Appendix 3:
Agency Correspondence

Joint Permit Application Package
Albany Port District Commission

**Port of Albany
Expansion Project**

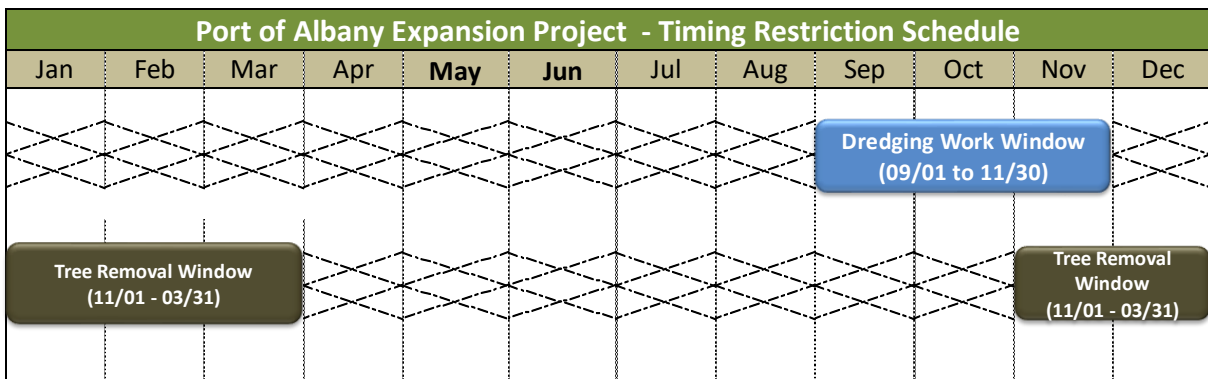
Comments # 16. *The proposed wharf dredge depth is significantly deeper than current conditions. Please describe what mitigation is proposed to offset potential impacts to shortnose sturgeon habitat.*

Response # 16: Proposed dredge depth is required to match current navigational depth of Hudson River (federal navigational channel) providing adequate separation and safe draft to vessels at the proposed wharf, and ability to the species to potentially swim under the vessels. Proposed depth is approximately 32 feet below the MLLW line, plus approximately two (2) feet of allowable overdredge.

According to the Sediment Sampling Analysis, the proposed dredging will occur over a substrate consisting of silty clay, sand and some trace of gravel, including Class C sediments. The proposed mechanical dredging would remove of approximately 105,000 cubic yards containing concentrations of pesticides and PCBs contributing to the cleanup and improving the quality of the Hudson River.
